CDM Final Validation Report

CDM Validation

Incheon Metro Line 2

324169 / P32041.33

The conceptual project boundaries are given in figure 3 of the PDD:

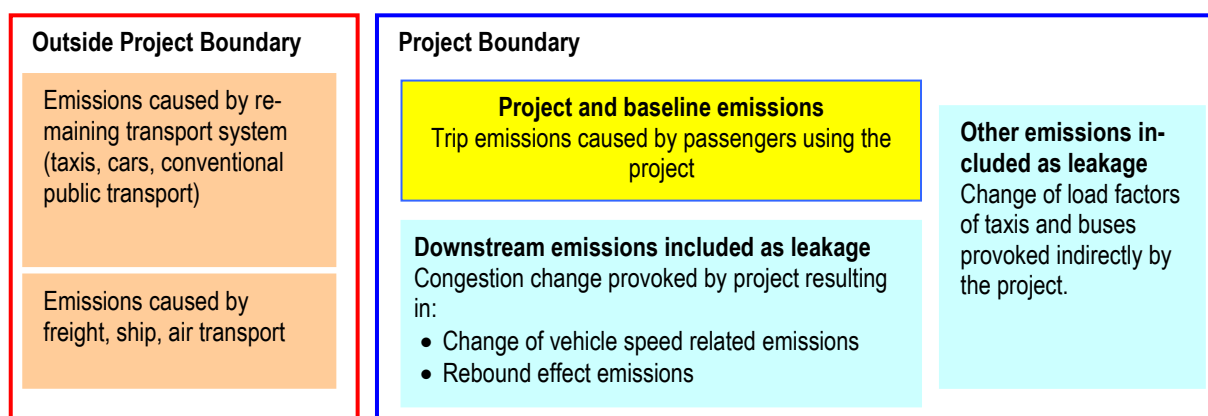
According to the methodology version 2 a "larger urban zone (LUZ) of a city covers the whole functional zone around the city (including the core city) i.e. it corresponds to the commuting field around the city"; it is thus justified to speak of a larger urban zone for the cities Seoul, Bucheon and Incheon, but it was not clear to the validators what the relationship between "larger urban zones", "Seoul Metropolitan Area SMA" and "Seoul National Capital Area SNCA" is. Therefore, CL 4 was raised. This was clarified in Chapter A4.1.4 of the PDD. The local expert agreed with the explanation, therefore CL 4 could be closed.

Validator request:	The context between a “larger urban zone LUZ”, the “capital metropolitan area” is not defined clearly enough. See also CL 18.		
Project owner response:	Has been clarified in Chapter A.4.1.4 and made consistent between chapters.		
Validator conclusion:	Adaption OK, CL 4 closed.	Date:	12/04/2012

Figure 6: Baseline and Project Emissions

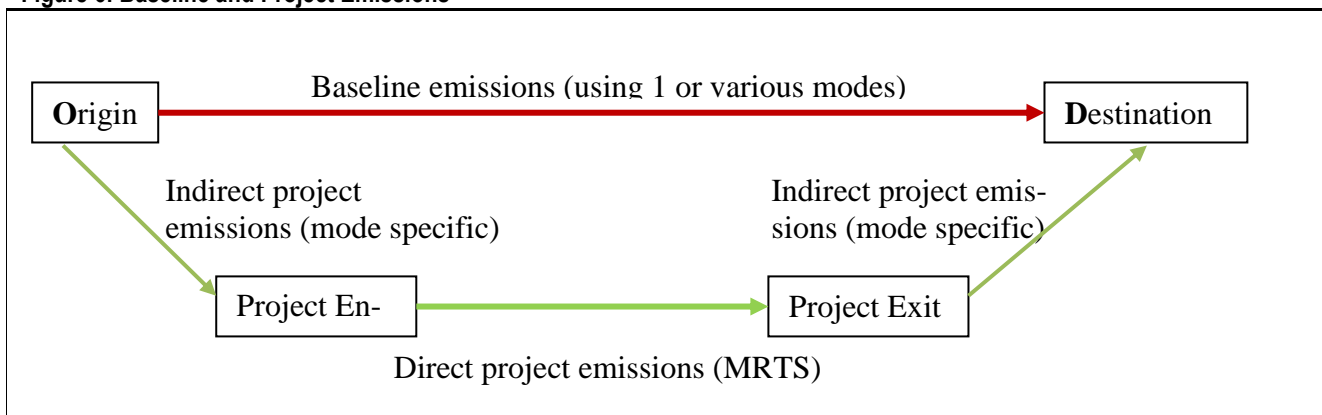
CL 11 was raised, since the site visit but also documents in the PDD revealed that the end of construction will be late 2014; so the first crediting period cannot start already in the beginning of 2014. The PDD was amended and the crediting period starts now on 01/01/2015.

No.:	CL 11	Reference:	PDD Annex 3
Validator request:	The end date of construction is mentioned as 18/11/2014. Why is the first crediting period already starting at the beginning of 2014?		
Project owner response:	Crediting period start is 01/01/2015		
Validator conclusion:	Tables with starting date 01/01/2015, OK, CL 11 closed.	Date:	12/04/2012
